CCC Audit of Midland - Judd, 21 May 2019

John Chamberlain, George Coulouris, Jean Dollimore, James Brander, Paul Allen and Simon Pearson

10. The crossover at the taxi pick up point

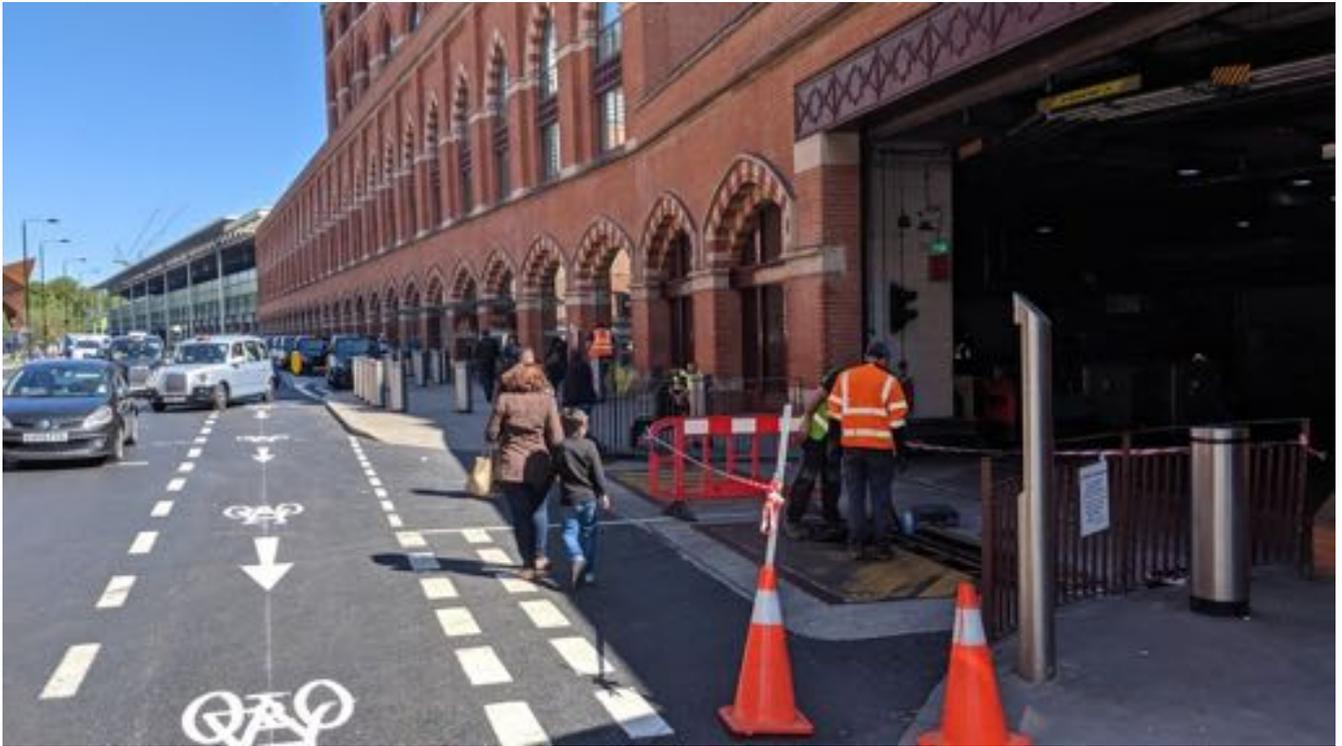
The crossover at the taxi pick up point seems to work reasonably well
